COMMON STRUCTURAL RULES FOR
BULK CARRIERS

Stress concentration factor for the hatch corners

Doubts in the CSR bulk formula (K_{gh})

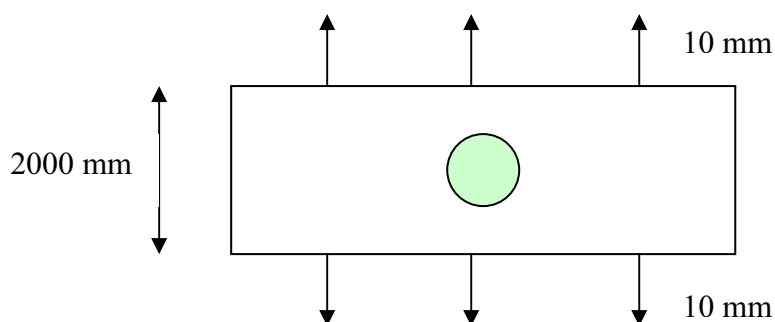
In the bulk formula, r_a is used for rounded corners (the radius in major axis) as a basis for elliptic corners. They attribute a correction factor to take into account the influence of elliptic shape.

with the following correction factor to apply to get the elliptic stress concentration factor from the rounded one:

$$f_c = \frac{1}{3} + \frac{2r_b}{3r_a}$$

ANSYS 9.0 tests

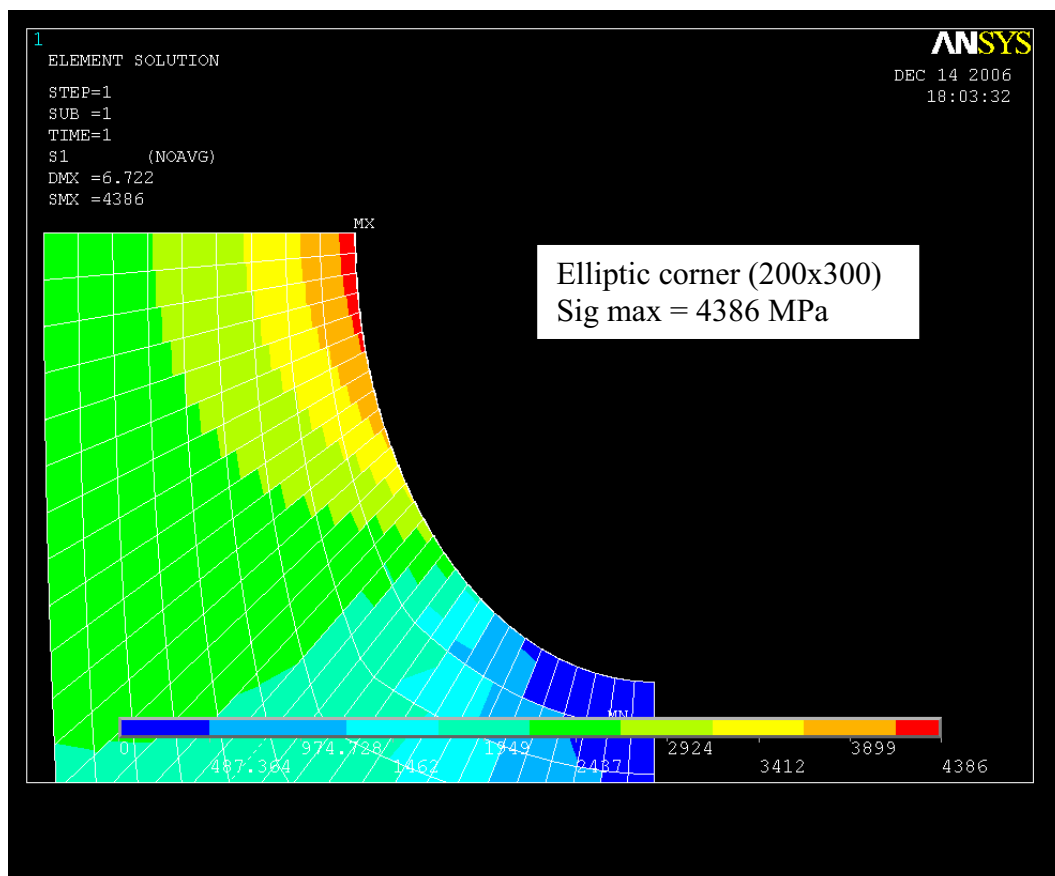
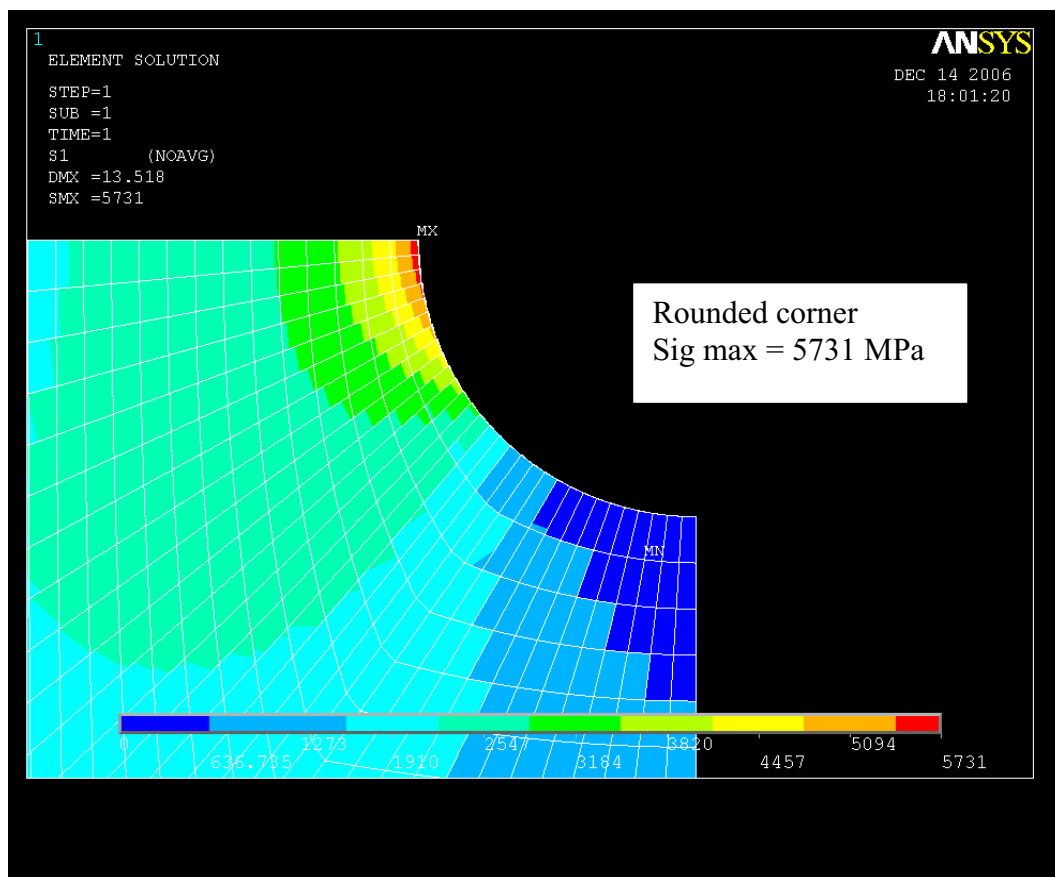
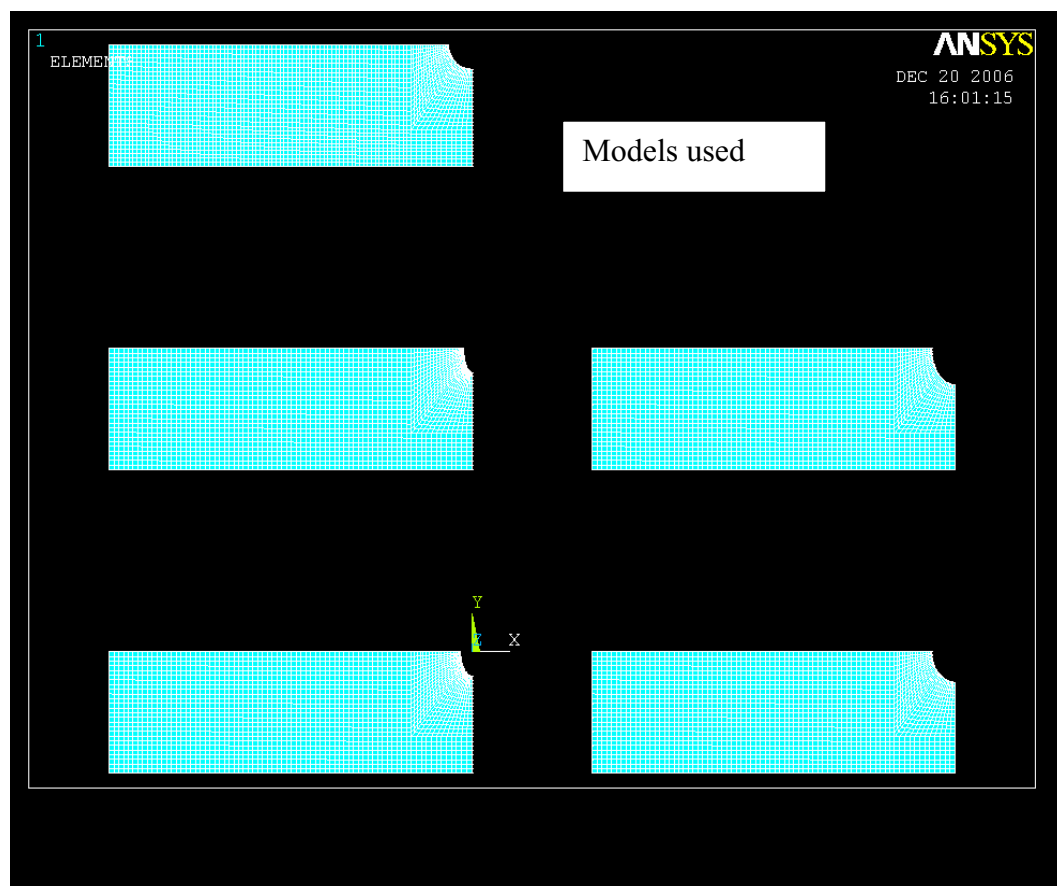
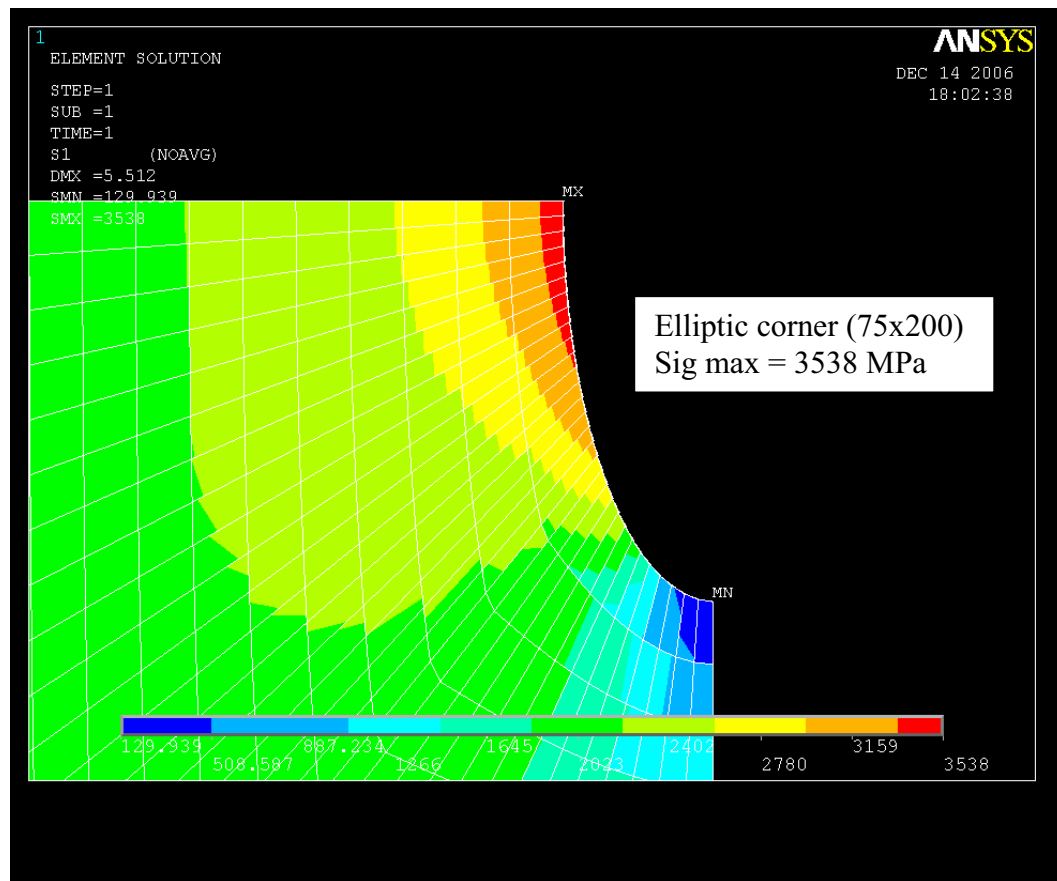
Comparison between K_t eval (f_c) and K_t real (ANSYS software) for the different ellipses

Shape	dimensions	Maximum stress	K_t real (Max stress/2060)	Correction factor f_c	K_t evaluated ($2.78 * f_c$)	K_t eval / K_t real
Circular hole	200x200	5731	2.78	1		
Ellipse 1	50x200	3057	1.48	0.5	1.39	0.94
Ellipse 2	75x200	3538	1.72	0.58	1.62	0.94
Ellipse 3	100x200	4009	1.95	0.67	1.85	0.95
Ellipse 4	200x250	4928	2.39	0.87	2.42	1.01
Ellipse 5	200x300	4386	2.13	0.78	2.17	1.02
Ellipse 6	200x400	3702	1.8	0.67	1.85	1.03

We can see that r_b radius is a more conservative basis than r_a to evaluate the influence of an elliptic shape. The error is a bit less than for r_a and the K_t obtained is over evaluated (r_b basis) instead of being under evaluated (r_a).
